10/799,750

Peter T. O'Heeron

MENDOZA, MICHAEL G

Office Action Summary

FIG. 1

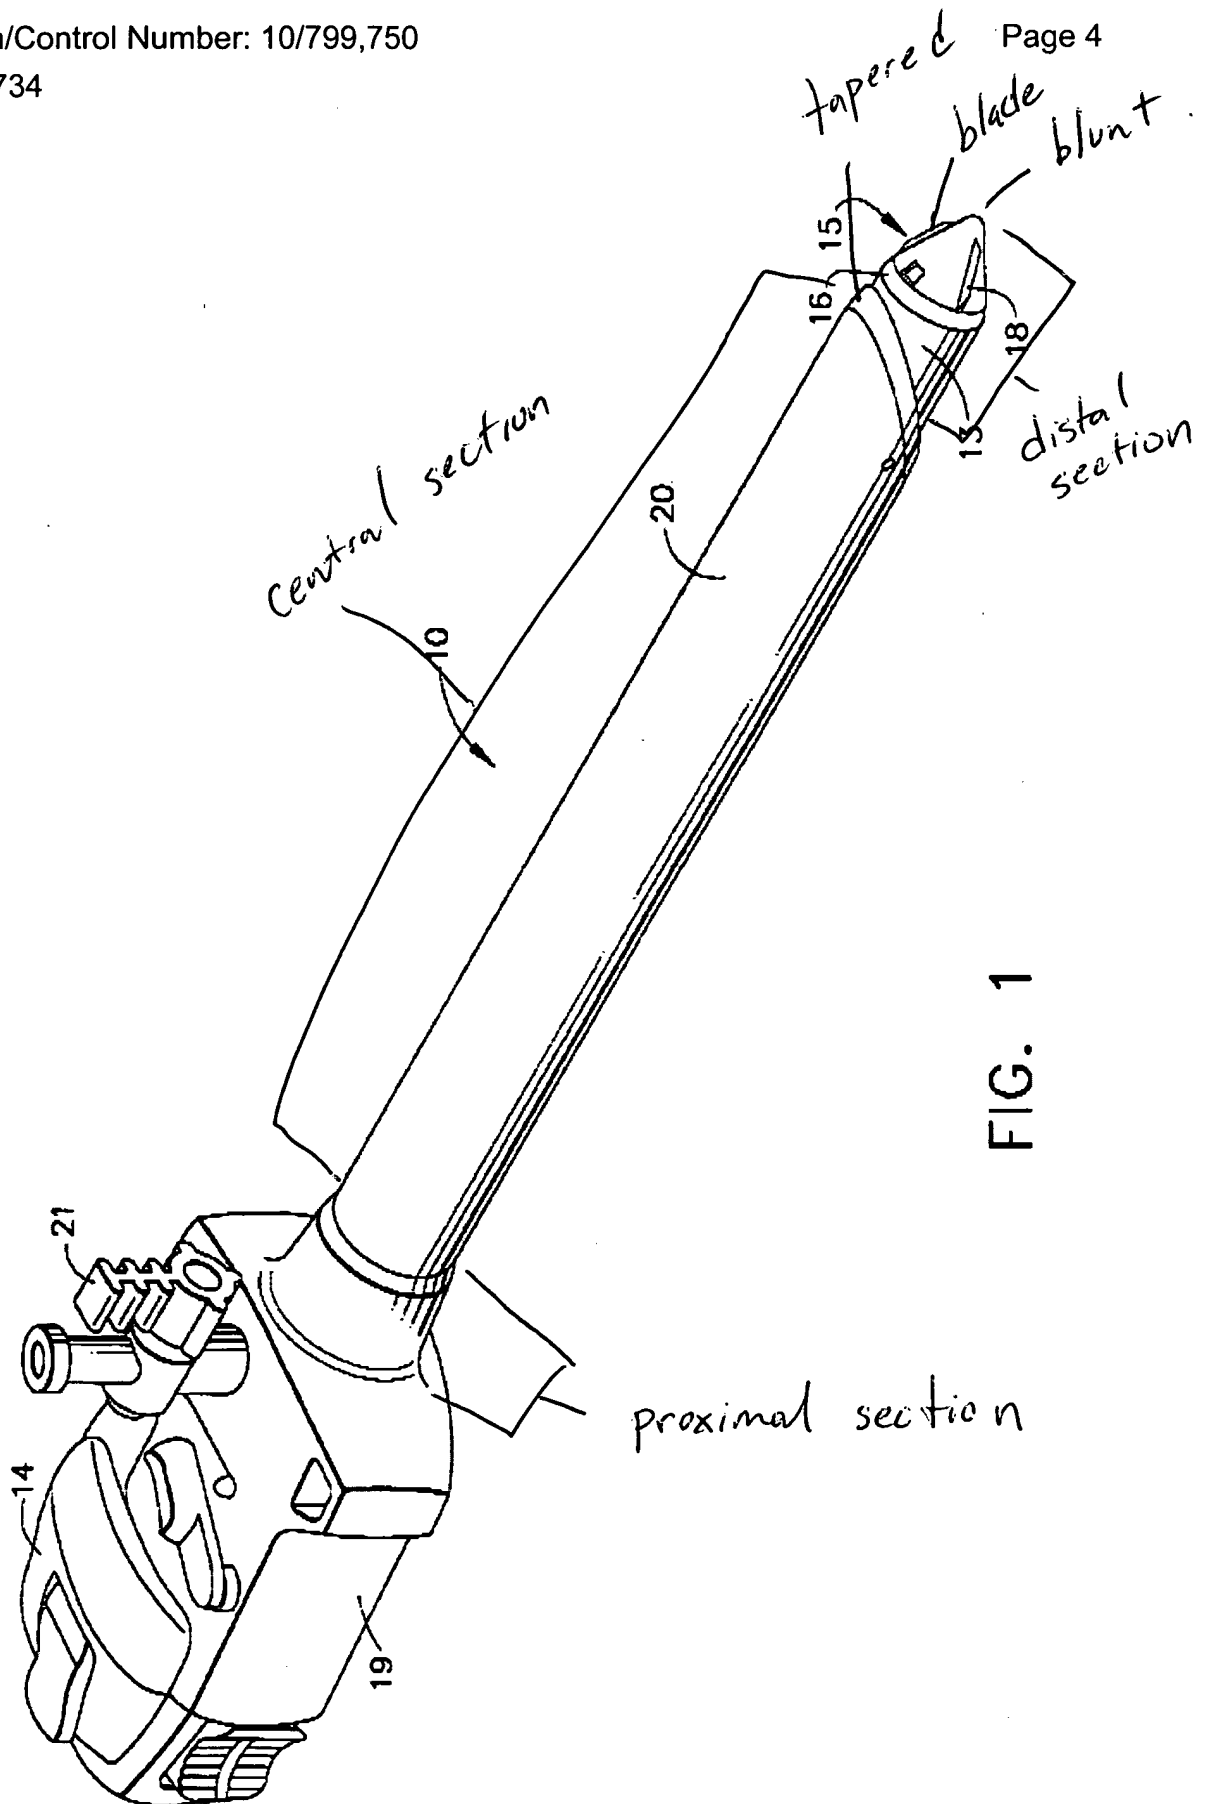
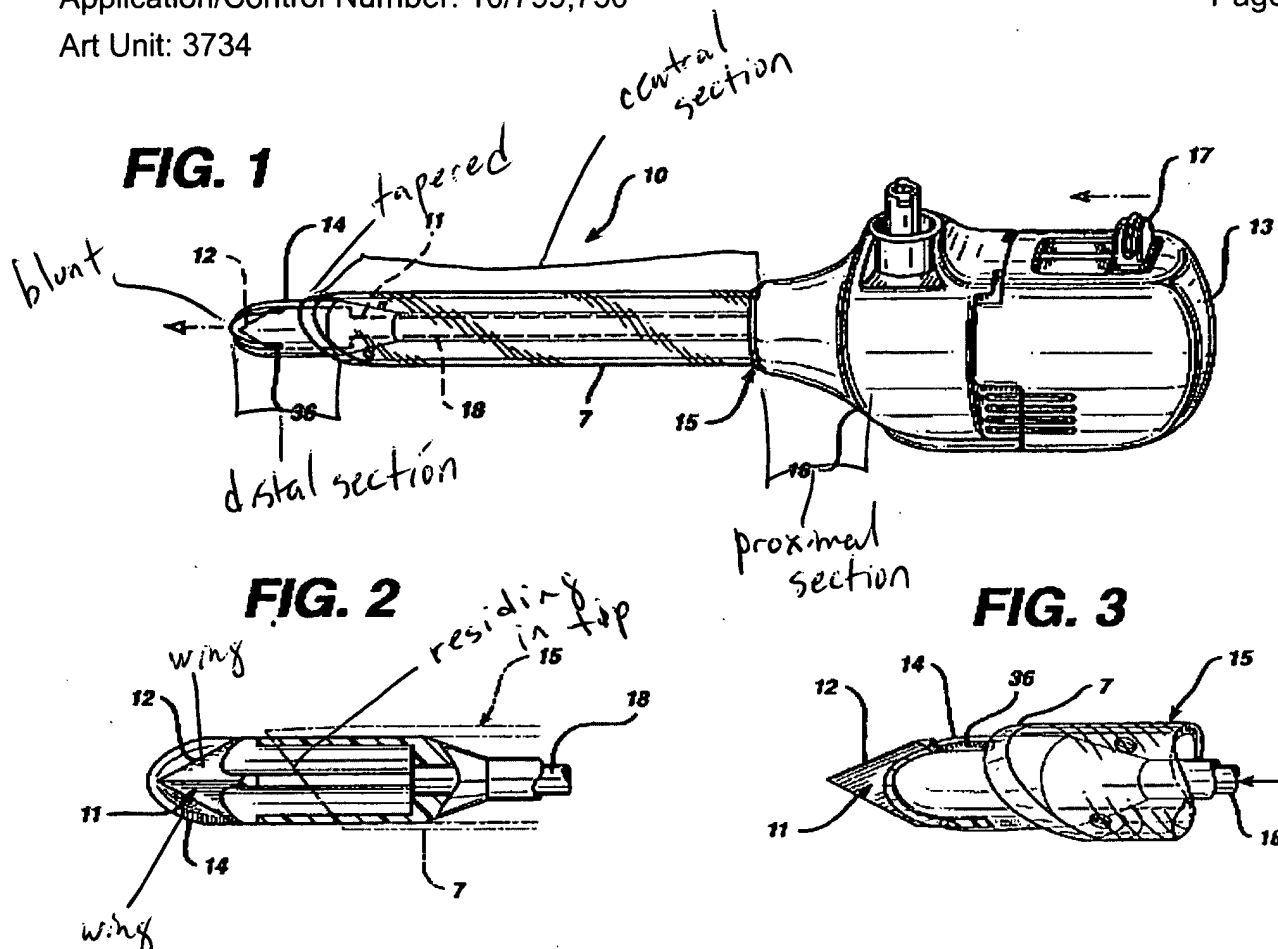
3. Claims 1-3, 5, 6, and 8-11 are rejected under 35 U.S.C. 102(b) as being anticipated by Goodwin et al. 5817061.

4. Goodwin teaches an obturator tip having a longitudinal axis, said tip comprising: an elongated distal section having a first diameter, said distal section having a blunt, rounded, distal end for separating tissue; an elongated proximal section having a second diameter, a central section for connecting said distal section and said proximal section; and a pair of blades located on opposing sides of said tip, said blades positioned about 180 degrees apart from each other; wherein said central section further comprises tapered outer surfaces for connecting said proximal section and said distal section; wherein a first end of at least one of said blades is attached to said distal section of said obturator tip; wherein said second diameter is greater than said first diameter; wherein said outer surfaces of said central section taper in a linear fashion; wherein said blades have an arc shaped configuration; wherein said blades have upper and lower surfaces, said upper surfaces sloping in a downward direction; wherein said first diameter of said distal section is uniform; and wherein said second diameter of said proximal section is uniform.
